KRB STUDY REQUEST 8: Whitewater Flows

COMMENTS AND RESPONSE

KRB SR-8: WHITEWATER FLOWS UPDATED STUDY PROPOSAL

No. Kern - Above Fairview Dam

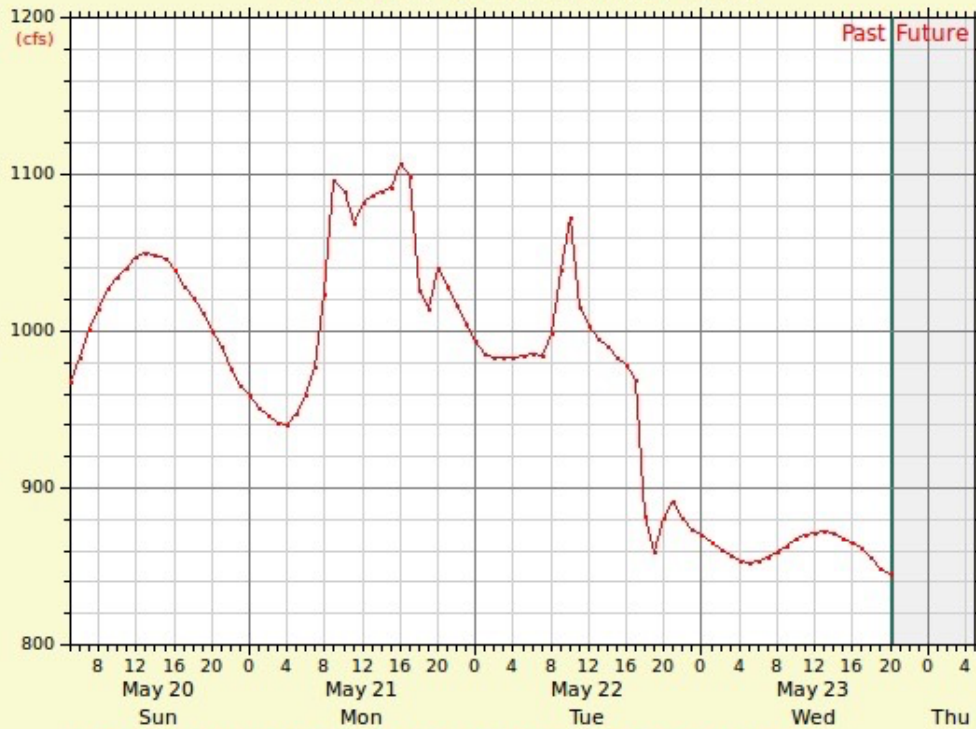
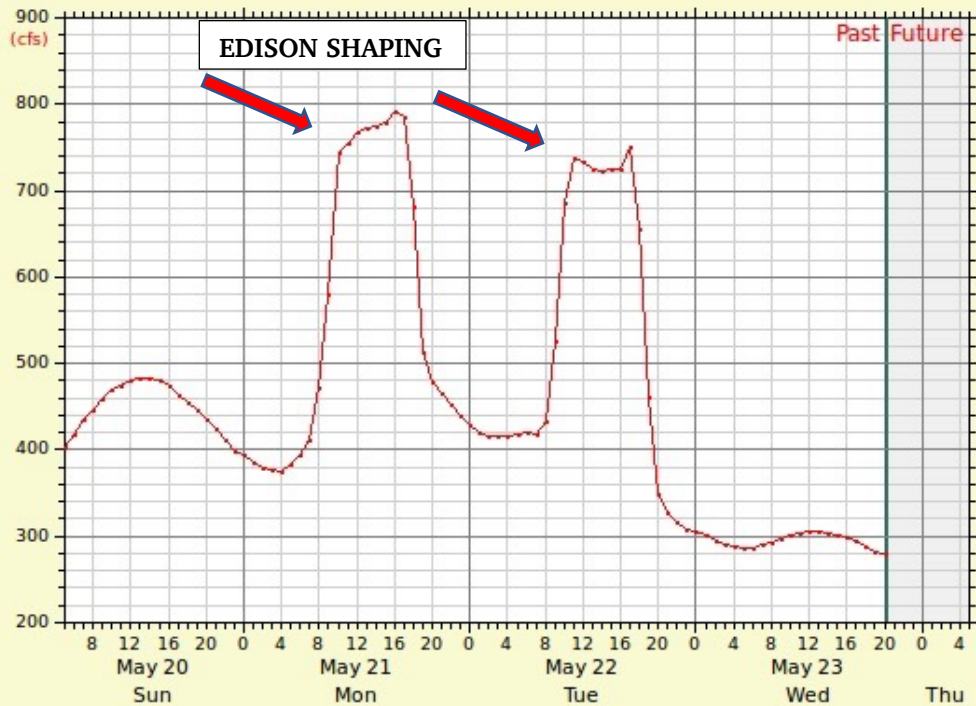
Here is an example of Edison shaping flows in the dewatered reach from May 2018; the first chart shows flows above Fairview Dam, the second below:

As can be seen above, flows above Fairview Dam between 10 a.m. and 5 p.m. on May 21 were between 1,000 and 1,100 cfs. Edison was able to shape the flows below Fairview and keep them at about 775 cfs (760-790). On May 22, incoming flows were 980 to 1,070 cfs, and Edison shaped flows below the dam at about 730 cfs (720-740).

The fact that Edison can shape flows below Fairview anywhere between the level of incoming flow to a level 600 cfs below that figure means there is a vast inventory of days upon which different flow levels could be tested in the dewatered reach. KRB took the daily average flow data from the last 25 years²²⁶ and found the following average numbers of days upon which different flow levels could be tested annually:

We have updated our study request to reflect this information.

No. Kern - Above Fairview Dam

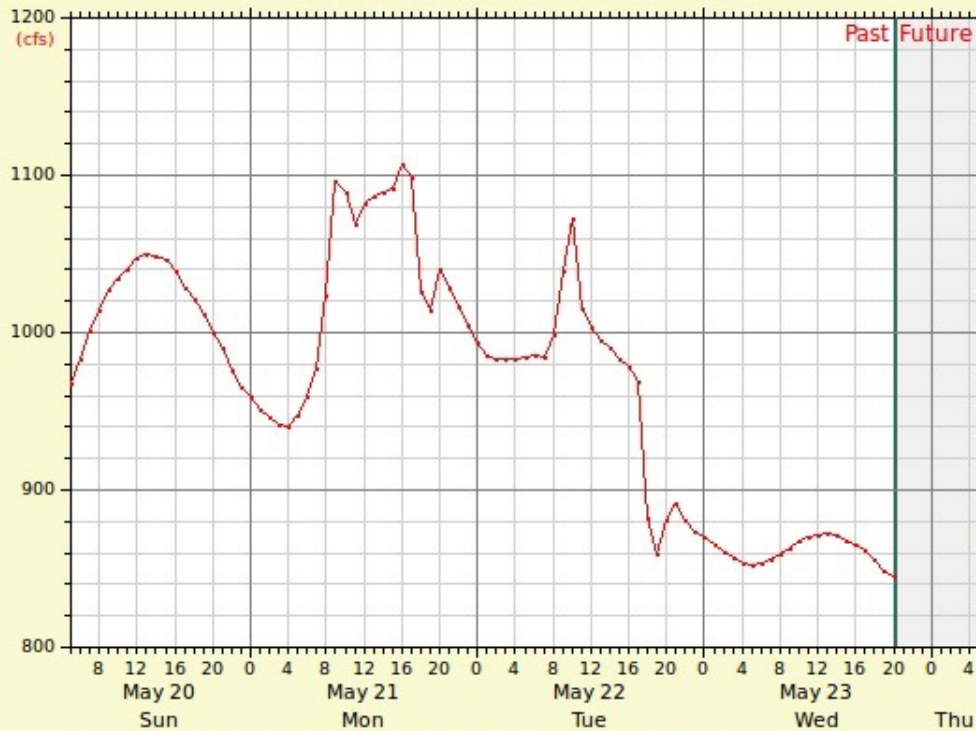
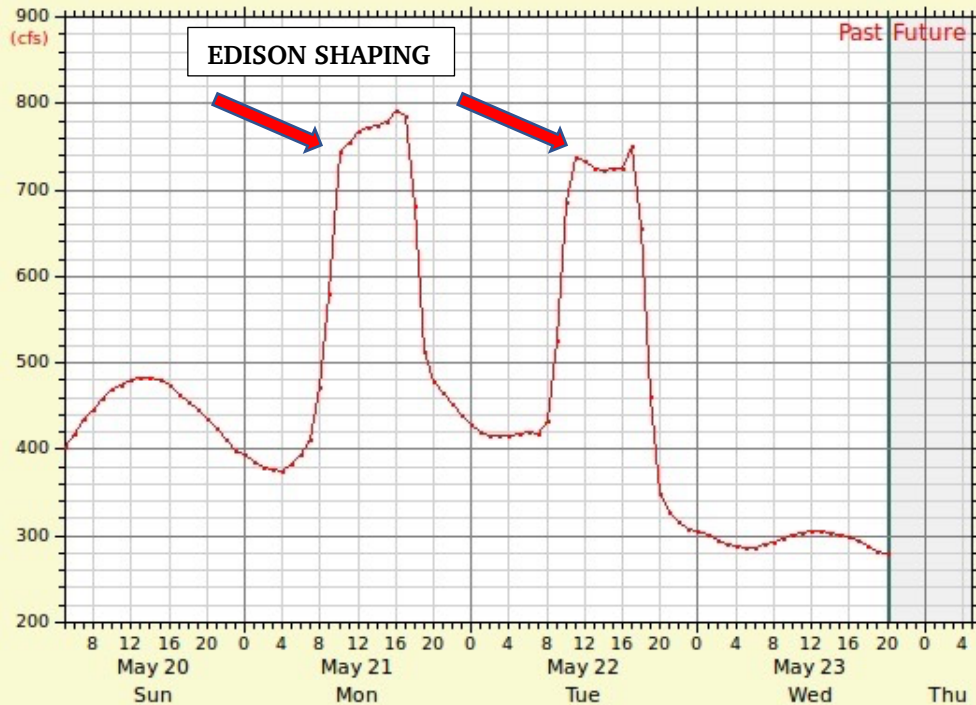
Here is an example of Edison shaping flows in the dewatered reach from May 2018; the first chart shows flows above Fairview Dam, the second below:

As can be seen above, flows above Fairview Dam between 10 a.m. and 5 p.m. on May 21 were between 1,000 and 1,100 cfs. Edison was able to shape the flows below Fairview and keep them at about 775 cfs (760-790). On May 22, incoming flows were 980 to 1,070 cfs, and Edison shaped flows below the dam at about 730 cfs (720-740).

The fact that Edison can shape flows below Fairview anywhere between the level of incoming flow to a level 600 cfs below that figure means there is a vast inventory of days upon which different flow ranges could be tested in the dewatered reach. KRB took the daily average flow data from the last 25 years²⁵⁰ and found the following average numbers of days upon which different flow levels could be tested annually:
